Docket Item # 1  
BAR CASE # 2016-0231

**ISSUE:** Certificate of Appropriateness for Alterations to Previously Approved Plans

**APPLICANT:** 211 West Street, LLLP by Gaver Nichols, Architect

**LOCATION:** 211 North West Street

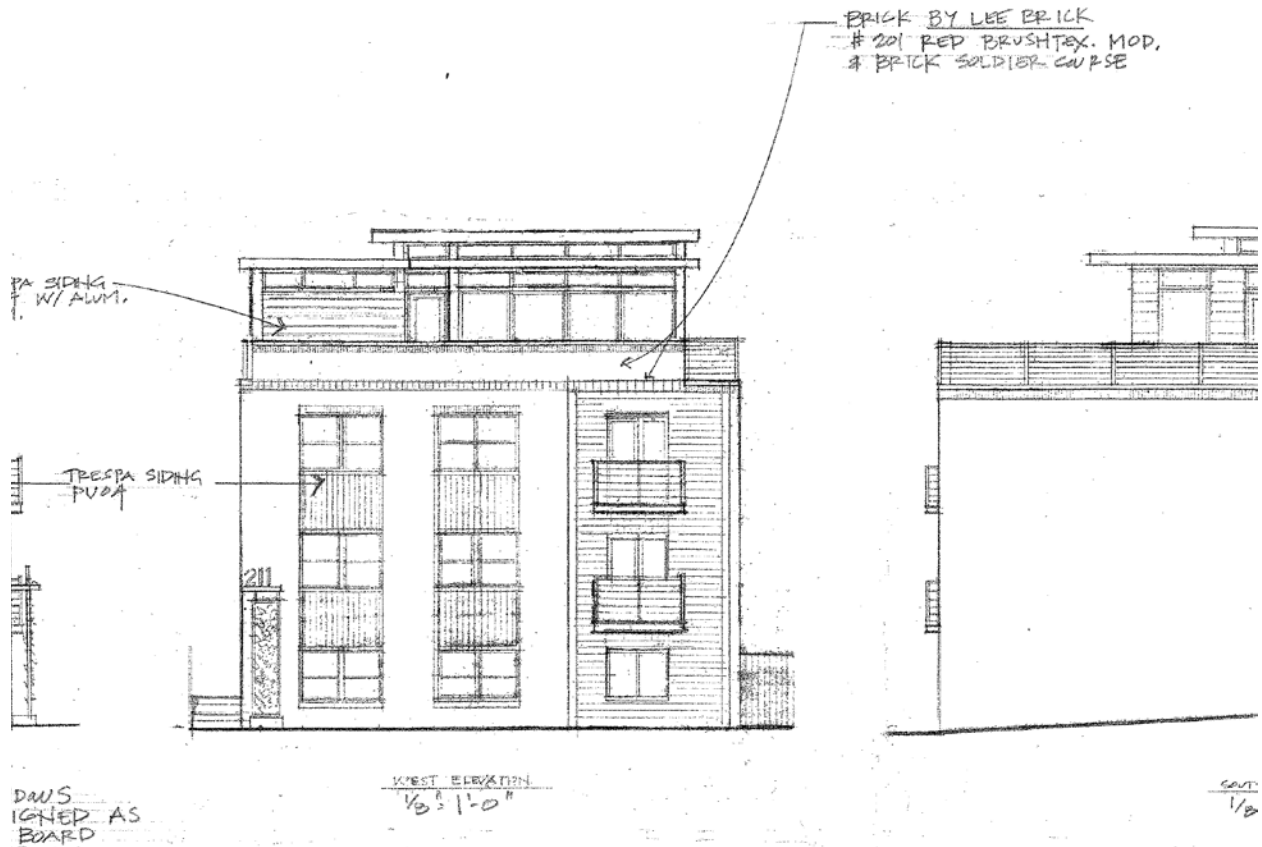
The applicant was asked to work with staff on the unresolved details of the front façade, including removing the pilasters, carefully matching any new brick with the existing brick, and installing the fiber cement spandrels on the brick. Rather than removing the engaged brick pilasters altogether, the applicant now proposes to infill the masonry wall area between by them with the same siding material that will be used as spandrels between the windows and to clad the fourth-floor addition. This decision was made, in part, because finding an exact match to the original brick was impossible and the applicant believes that, after the existing balcony door apertures are reduced in size, even the closest matching brick will contrast with the original material and illustrate where the brickwork was reworked. Applying siding to this area between

the pilasters will hide the new brickwork as well as visually tie this bay to the other siding-clad elements, namely on the top floor addition. The applicant suggests further tying the old material with the new by creating a brick soldier course at the fourth floor level with modern bricks that are similar in color to the existing masonry, but with a slightly rougher texture. The applicant has attained mortar which matches the existing mortar. BAR staff believes the horizontality of the proposed synthetic wall cladding material between the pilasters will visually correspond to and reinforce the horizontal boards covering the fourth-floor addition and that these will make a positive visual contrast with the original brick mass.

However, staff is concerned that if the fourth-floor addition, the area between the existing windows, plus the area between the pilasters are all clad in the new synthetic siding material that the original brick exterior will be overwhelmed and obscured by the new synthetic cladding. In addition, unlike the new construction or the infilled area framed by the projecting pilasters, the applicant proposes to apply the siding to the spandrels between the window frames directly to the surface of the brick wall like wallpaper. This will not appear to be an integral or original design feature and will potentially lead to delamination and future maintenance issues on the highly visible front facade. Therefore, staff suggests that the architect eliminate the vertical siding in the spandrel area between the heads and sills of the existing windows on the eastern and western elevations and discuss with BAR staff other options for the vertical siding between the existing windows on the north elevation.

1. The applicant must work closely with BAR staff on the final design of the proposed exterior wall cladding, especially in regard to eliminating the spandrels between the heads and sills of the windows on the east and west elevations of the existing structure and reconsidering the configuration of the spandrels on the north elevation.

*Figure 6: Example of Trespa siding: German School (2013) in Potomac, MD by Geier Brown Renfrow Architects*

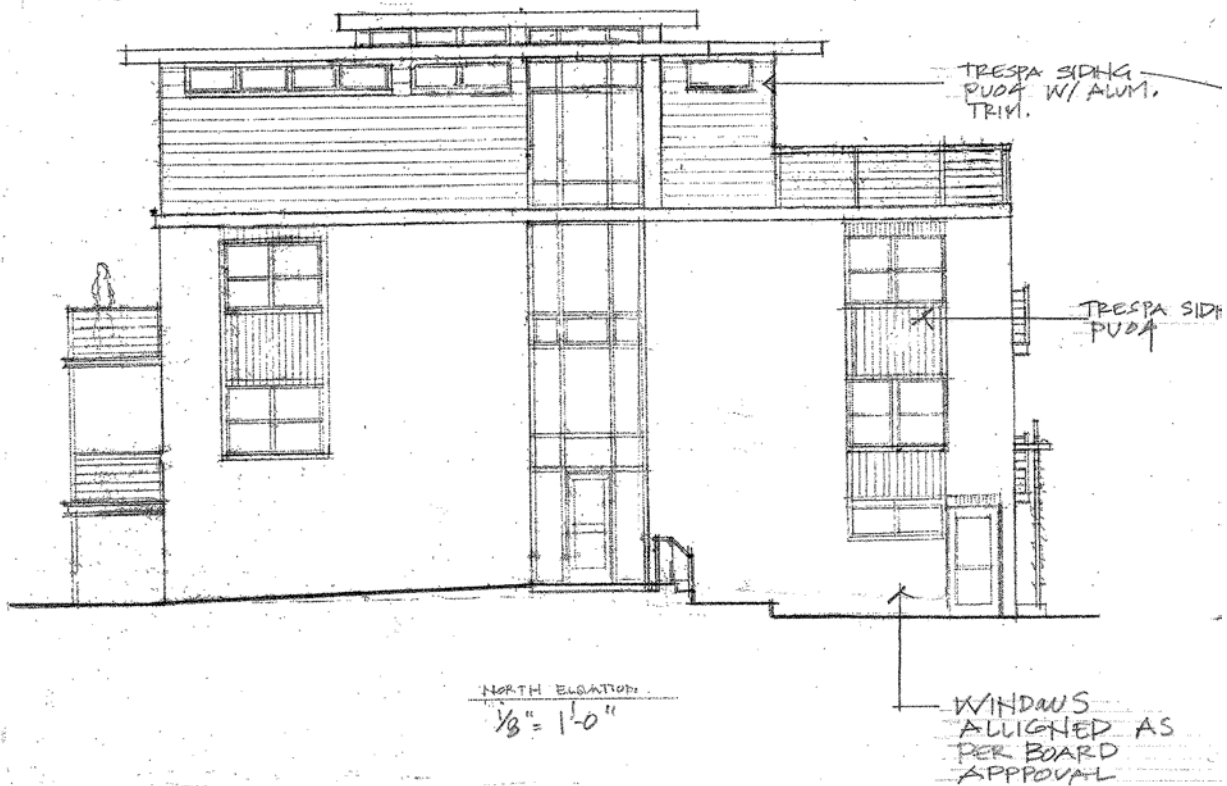
BAR staff is concerned that Trespa's durability has yet to be tested, as the oldest known project in the region is less than a decade old. While the applicability of Trespa to contemporary designs is suitable, its use on an older building within the historic district has no precedent. BAR staff is also strongly concerned that the proposed mahogany color choice seeks to intimate wood. The BAR does not support synthetic siding with an imitation wood grain surface texture, and although this Trespa sample has a smooth texture, it replicates a wood grain pattern and the intent of its hue is to closely replicate natural wood products. BAR staff strongly suggests that the architect consider authentic durable hardwood panels, such as Ipe, or alternate colors of synthetic siding that better reflect the modern materiality while still complimenting the red brick and without overwhelming its historic neighbors. This is also an opportunity to highlight the original building's Mid-Century design: using Carrera glass or porcelain tile could allude not only to a Mid-Century aesthetic but tie this new construction in with bolder contemporary designs seen in urban settings today.

2. The applicant must work closely with BAR staff on the choice of cladding material, especially in regard to choosing a color and finish which does not replicate wood grain.
